## **BID ADDENDUM NO. 3**

### **Johnson Student Center**

### **Building Demolition, Increment 1 (Demolition) and Increment 2**

RANCHO SANTIAGO COMMUNITY COLLEGE DISTRICT  
SANTA ANA, CA

SHEET TITLE  
**SIGNAGE DETAILS**

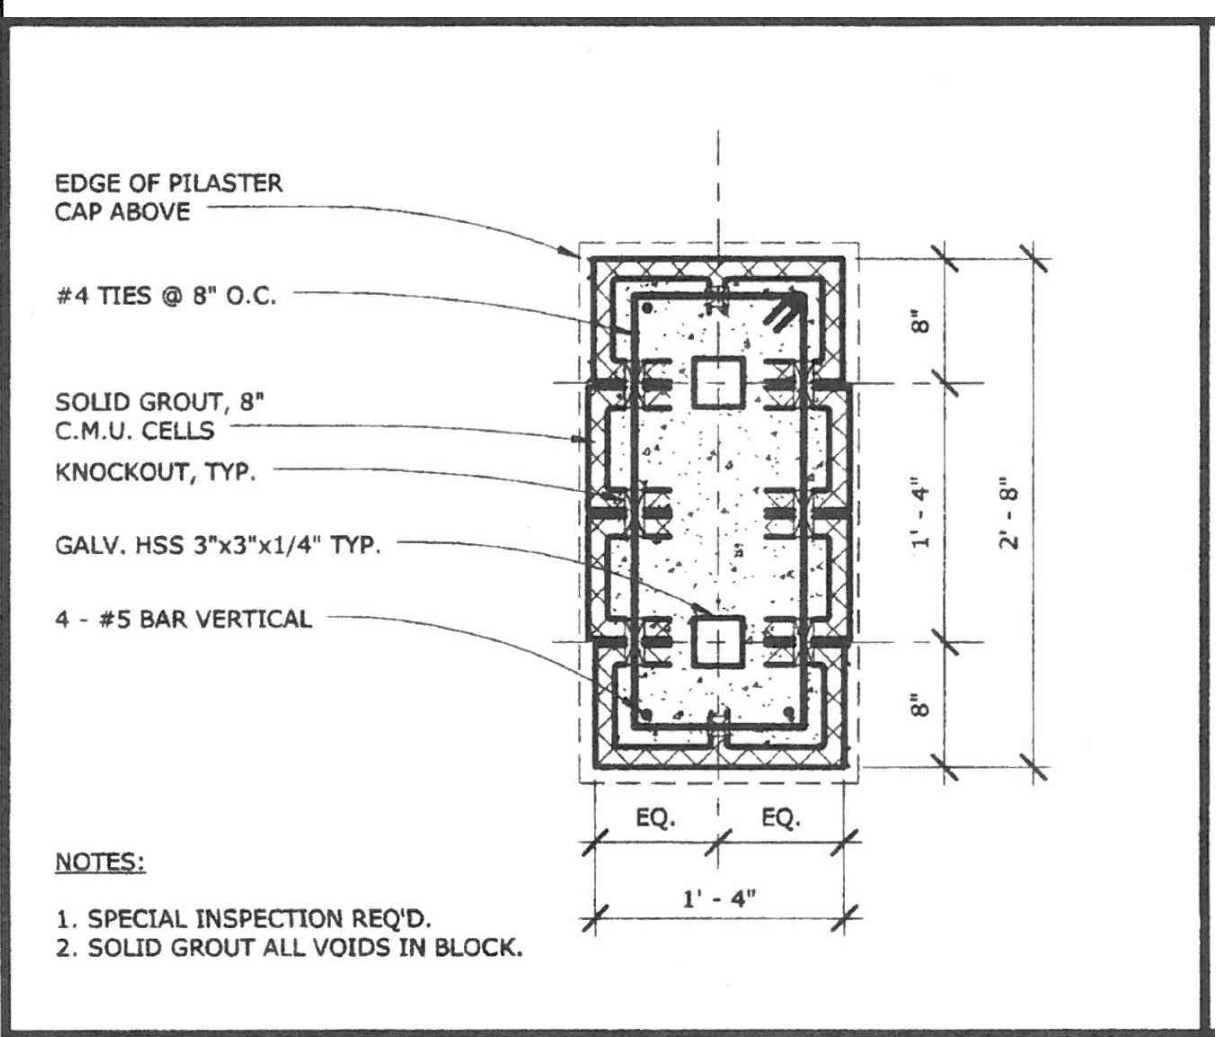
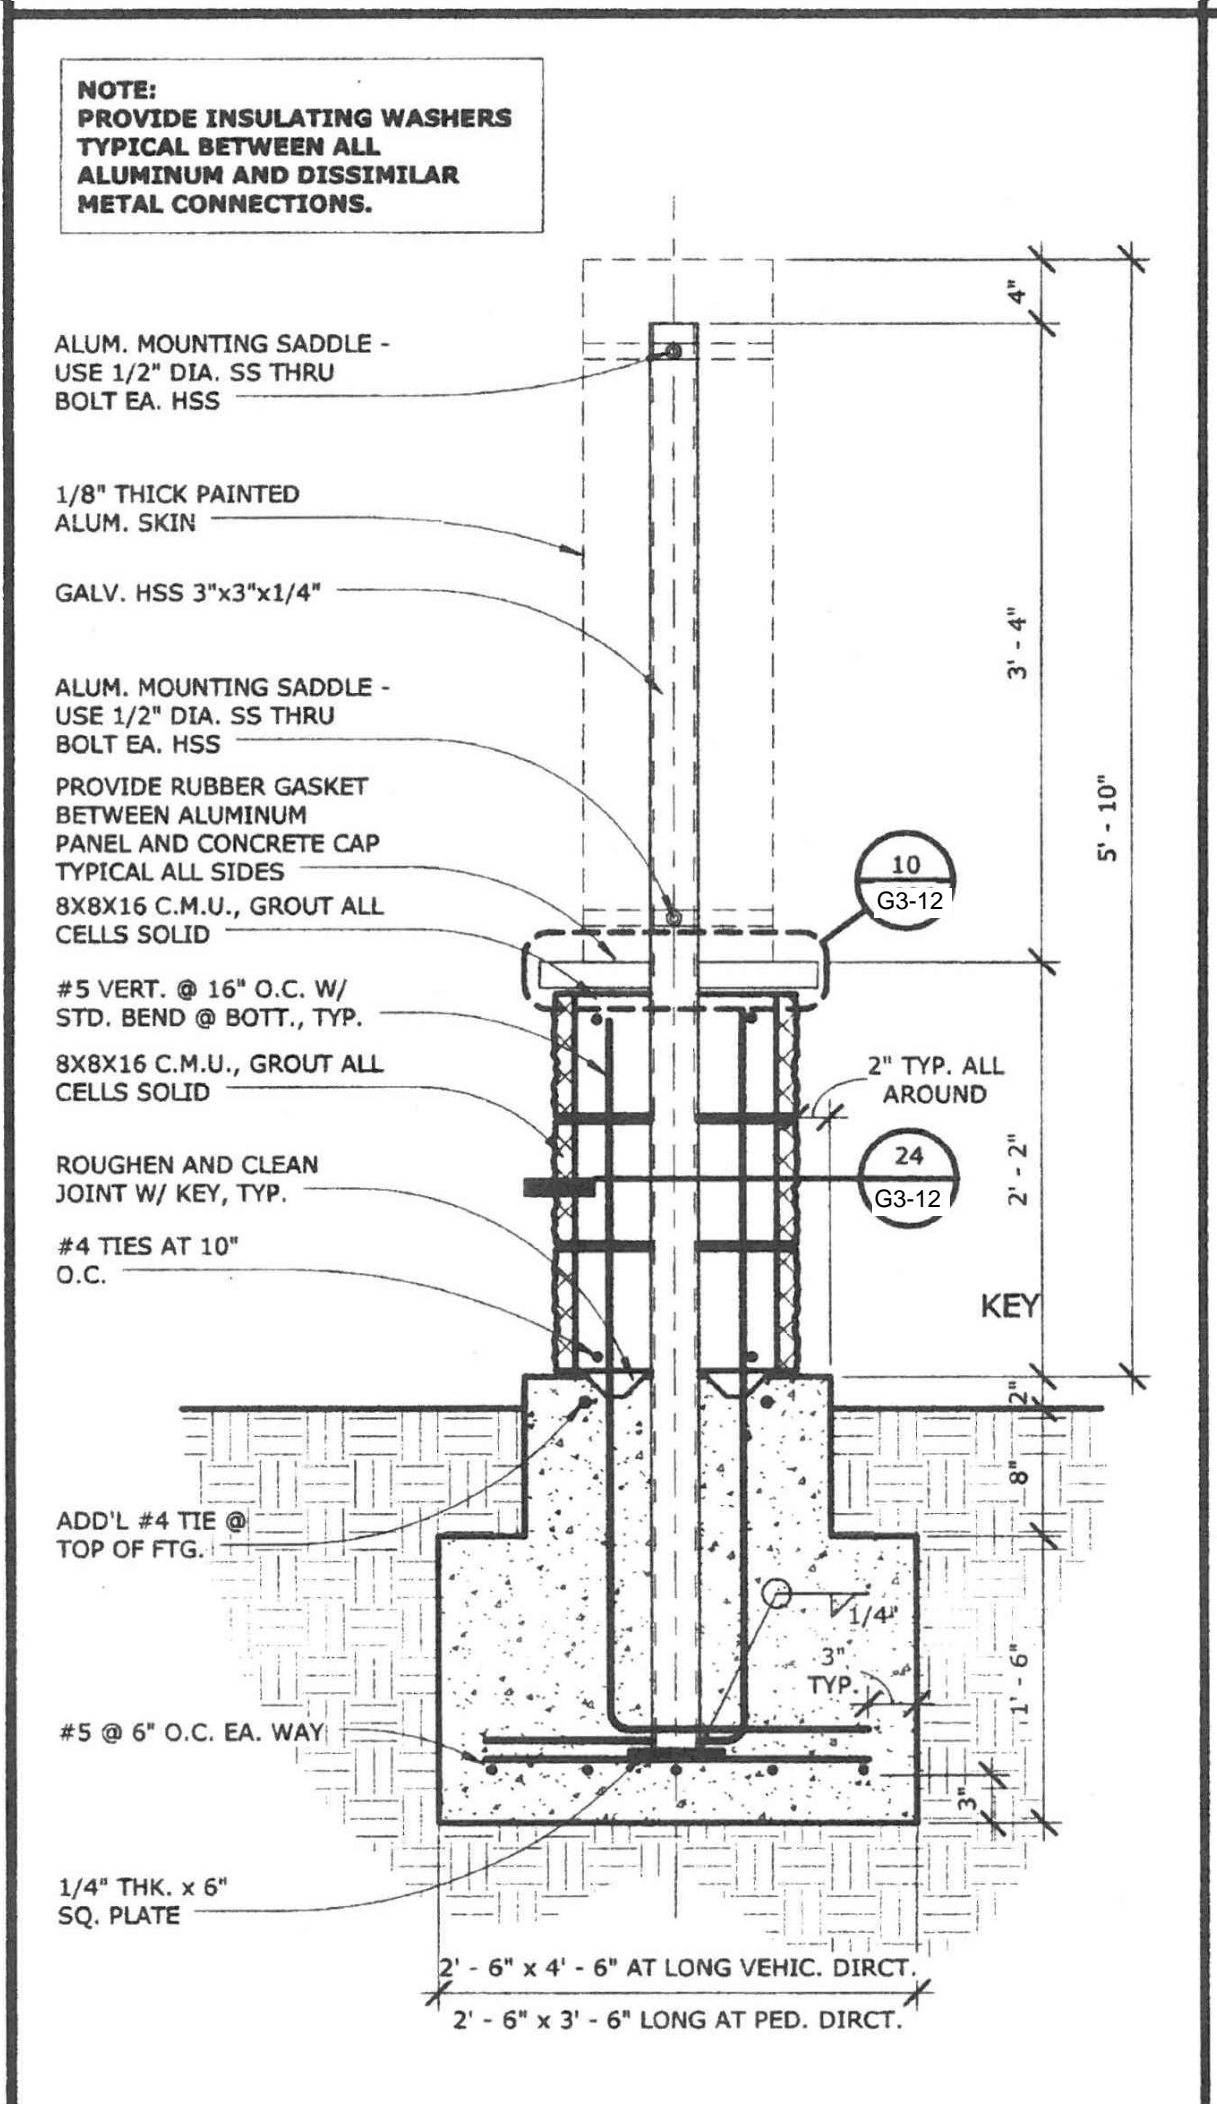
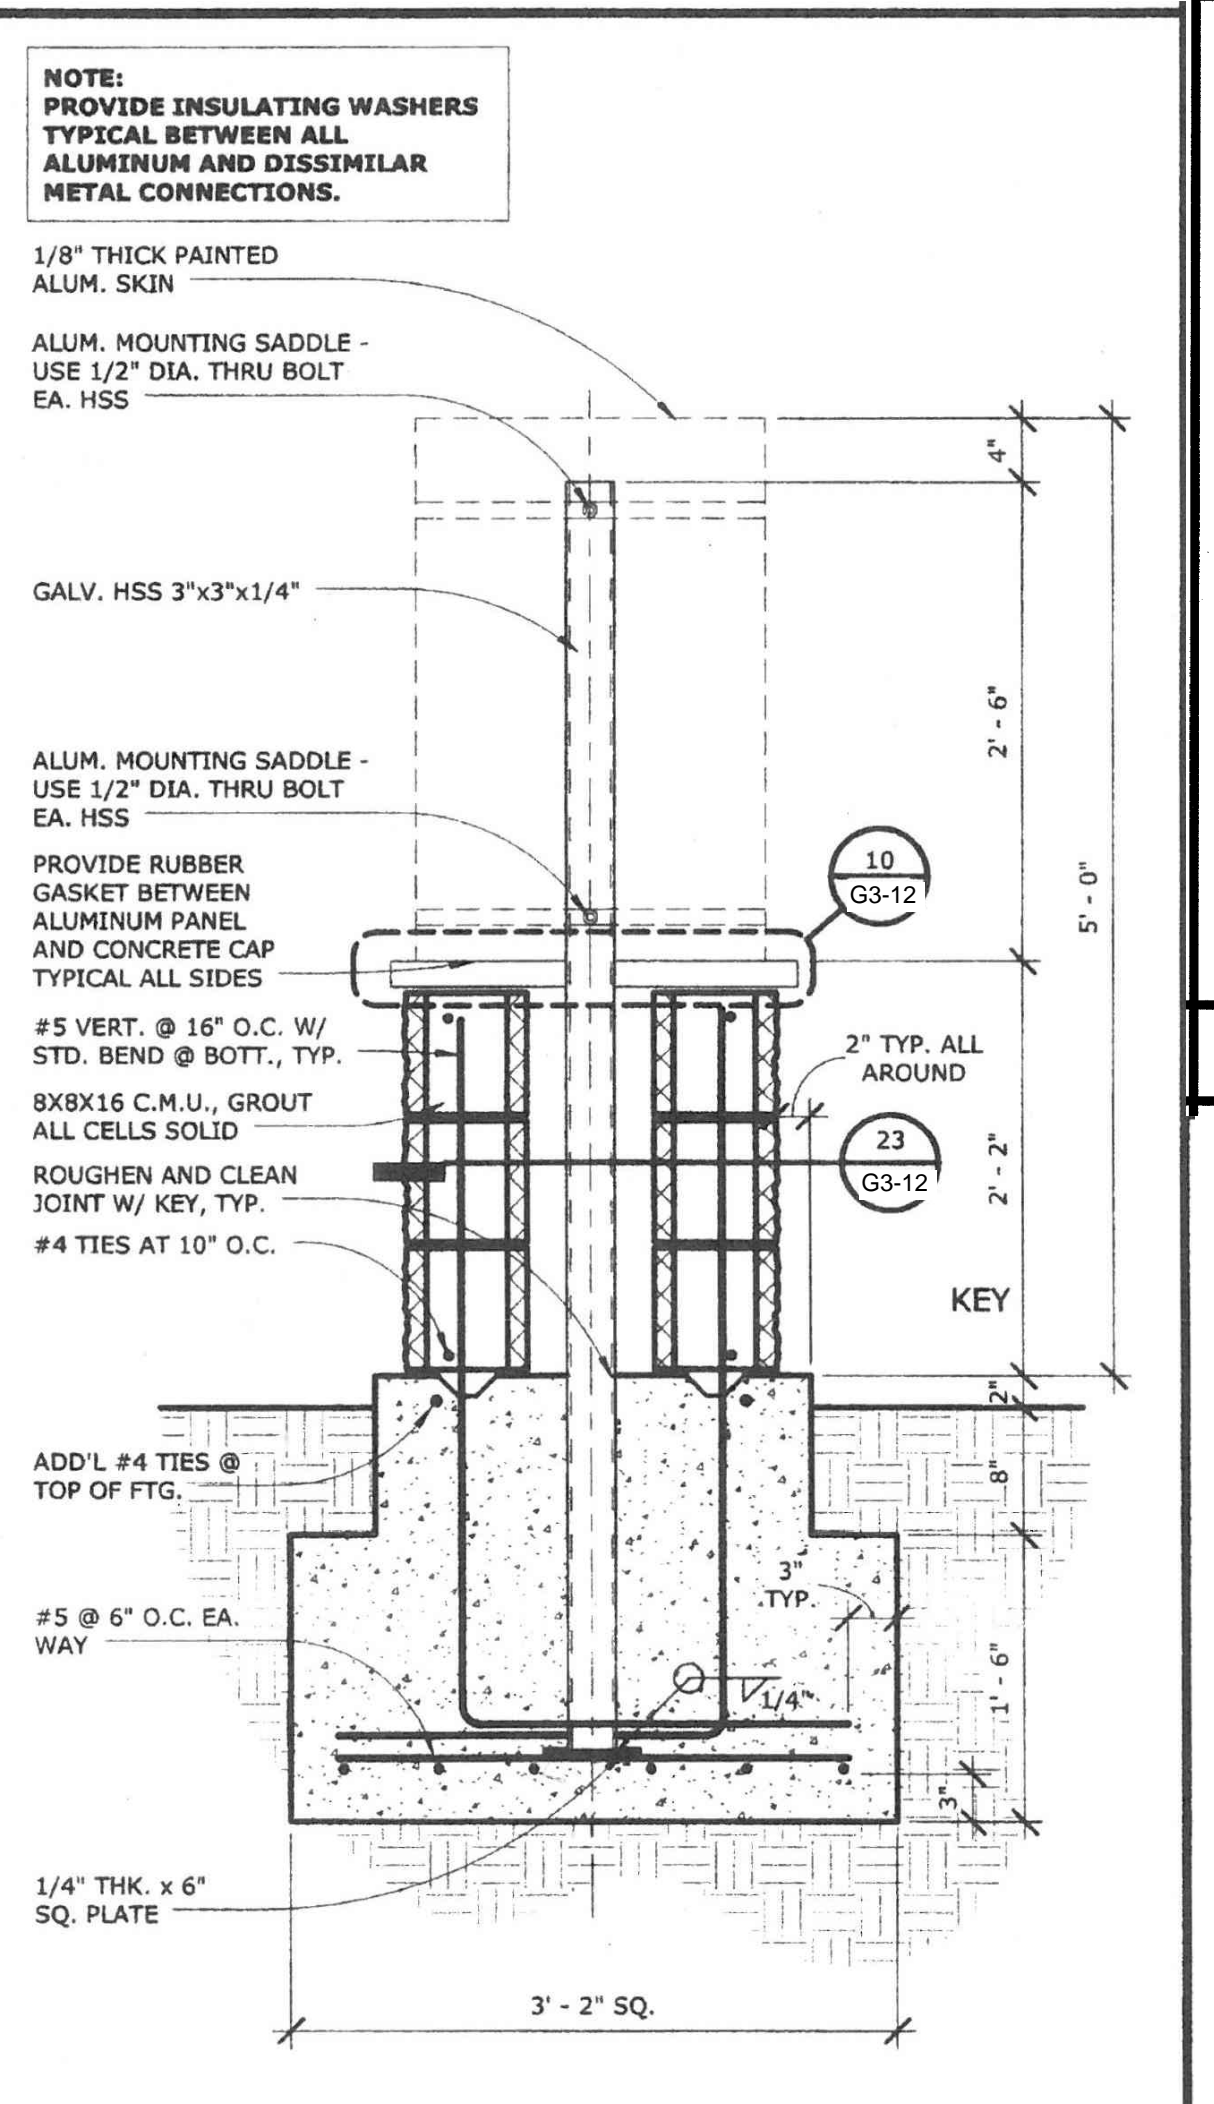
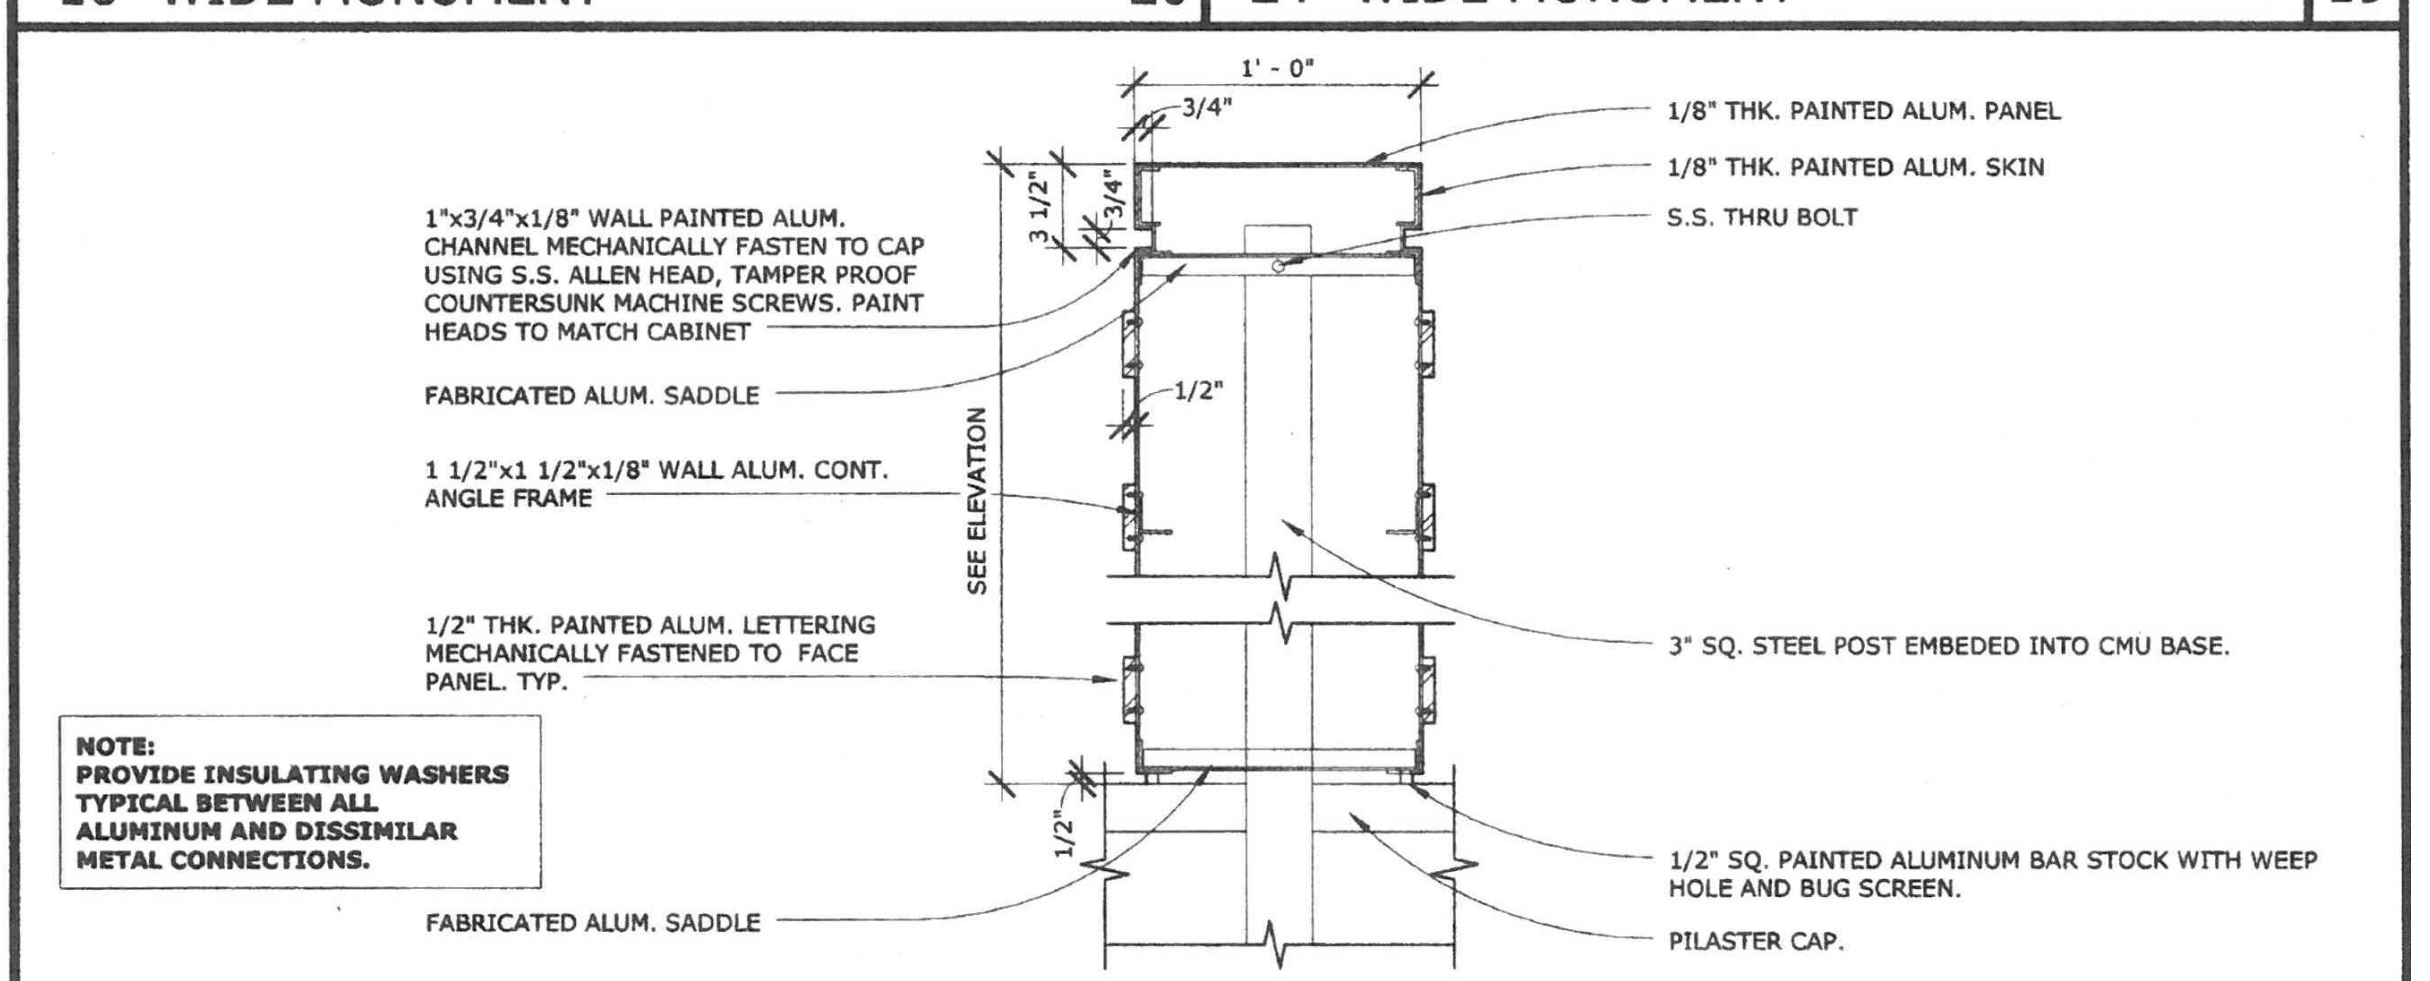
- Increment 2
  - i. General Contractor to provide an Exterior Material Mock-Up, refer to design drawings. Reference new sheets A0.01 and A0.02
- Increment 2
  - i. Added new detail sheet G3.12 (signage details) for monument / site signs.

- a. SERVICE YARD TO BE SPLIT FACE COLOR "SHORELINE"
  - b. PROVIDE: 8"h CMU, ANGELUS BLOCK - PRECISION "SHORELINE"
  - c. PROVIDE: 8"h CMU, ORCO BLOCK CO/WHITE - SPLITFACE 2-SIDES, MEDIUM WEIGHT BELOW THE SQUARE PRE-CAST CONCRETE BLOCK PILASTER 2" CAP.
- REFER TO NEW DETAIL SHEET G3.12 FOR ADDITIONAL INFORMATION**
